**RESOLUTION MEPC.261(68)**  
**(adopted on 15 May 2015)**

**AMENDMENTS TO THE 2014 GUIDELINES ON SURVEY AND CERTIFICATION  
OF THE ENERGY EFFICIENCY DESIGN INDEX (EEDI)**  
**(RESOLUTION MEPC.254(67))**

**Figure 2: An example of scheme of conversion from trial condition to EEDI condition at EEDI power**

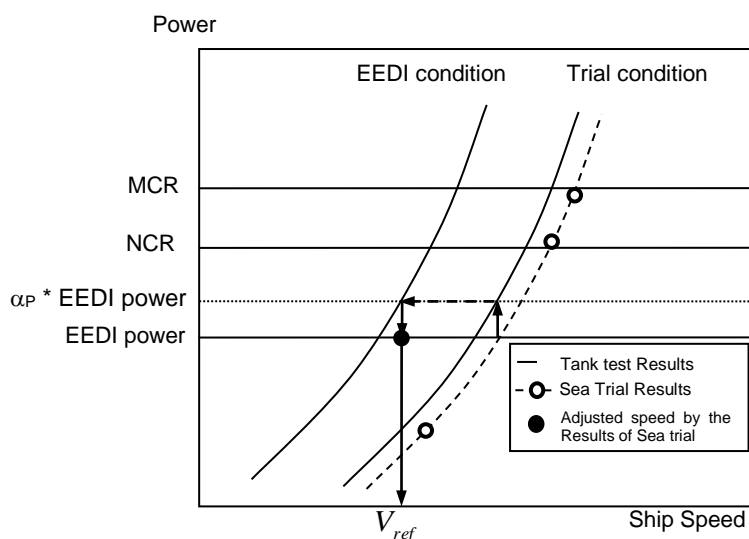
- .2 for ships for which sea trial cannot be conducted under the condition as specified in paragraph 2.2 of the EEDI Calculation Guidelines: if the measured ship speed at the power of the main engine as specified in paragraph 2.5 of the EEDI Calculation Guidelines at the sea trial conditions is different from the expected ship speed on the power curve at the corresponding condition, the shipbuilder should recalculate the attained EEDI by adjusting ship speed under the condition as specified in paragraph 2.2 of the EEDI Calculation Guidelines by an appropriate correction method that is agreed by the verifier.

An example of scheme of conversion from trial condition to EEDI condition at EEDI power is given as follows:

$V_{ref}$  is obtained from the results of the sea trials at trial condition using the speed-power curves predicted by the tank tests. The tank tests shall be carried out at both draughts: trial condition corresponding to that of the S/P trials and EEDI condition. For trial conditions the power ratio  $\alpha_P$  between model test prediction and sea trial result is calculated for constant ship speed. Ship speed from model test prediction for EEDI condition at EEDI power multiplied with  $\alpha_P$  is  $V_{ref}$ .

Figure 2 shows an example of scheme of the conversion to derive the resulting ship speed at EEDI condition ( $V_{ref}$ ) at EEDI power.

$$\alpha_P = \frac{P_{Trial,P}}{P_{Trial,S}}$$

where:

$P_{Trial,P}$ : power at trial condition predicted by the tank tests

$P_{Trial,S}$ : power at trial condition obtained by the S/P trials

$\alpha_P$ : power ratio
